**STAFF REPORT:** 09/11/2024 REGULAR MEETING

**APPLICATION NUMBER:** HDC2024-00437

**ADDRESS:** 1501 ATKINSON

**SCOPE:** REPLACE WINDOWS WITH VINYL WINDOWS, REPLACE DOORS, ALTER FRONT PORCH AND REAR DECK (WORK COMPLETED WITHOUT APPROVAL)

*Site Photo 1, by Staff Aug. 22, 2024: (North) front showing replaced vinyl windows, altered porch and landscape.*

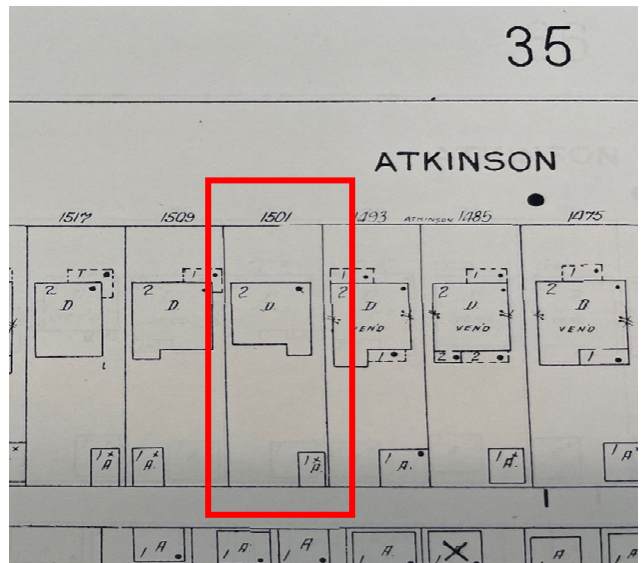
- Staff observed that the lengths of the wood sills and trim at the front face of the house have been slightly lengthened or thickened at the 2<sup>nd</sup> and 3<sup>rd</sup> stories. Also the brick ledge/sill along the first story ribbon of windows has been rotated from a diagonal to more perpendicular angle. It is staff’s opinion that these changes alter the historic narrow features of the window’s trim set against the stucco surface, creating a more square, blocky appearance that greatly alters the distinctive character-defining features of the façade’s fenestration.

- Staff observed from Sanborn maps that neither a front or rear porch were shown as features to the house. (See Sanborn image.)
- It is staff’s opinion that a front roof overhang once occupied the location where the current front roof is located, supported by a bracket (see site photo 1, fig 1&2). While the current construction is located approximately to the original, staff has the opinion that the introduction of a sloped roof at this location, rather than the original, near-flat structure, creates a heaviness and covers more than an appropriate amount of the front face of the façade, thus changing the architecture of the house.

- It is staff’s opinion that the repoured front porch deck, steps and front walkway meet the Standards and are appropriate. However, the installation of the brick wingwalls introduces a symmetrical feature that further detracts from the English Cottage style, which features asymmetry and a modest entrance. Along with the removal of the landscape foundation plantings, and the installation of symmetrically placed evergreens (see below), this introduced symmetry creates a pronounced entrance that is more conducive to Colonial styles and is incompatible with the modesty and assymetry of the English Revival form.

*Fig 2, by Google Street View, June 2019: (North) front elevation showing conditions prior to previous owner.*

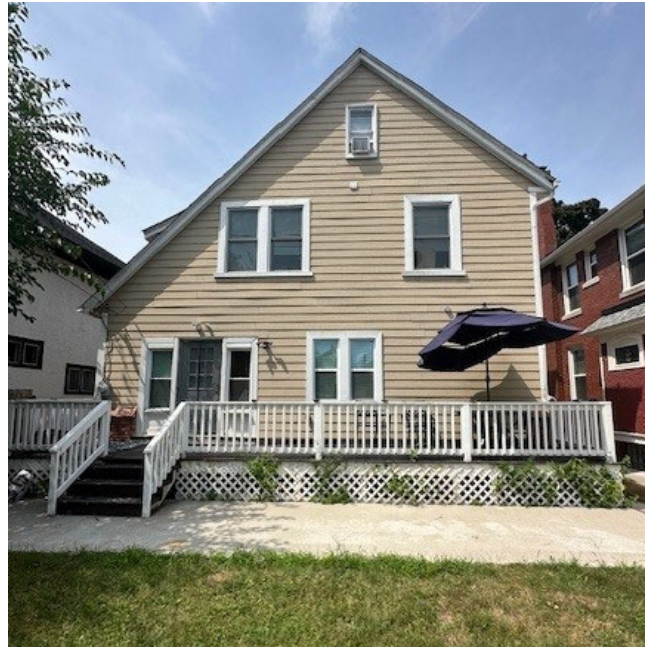
- No documentation of the condition of the original windows was available but staff observed that the wood windows were present until at least 2019 from Google Street View images. (See figures 1&2)
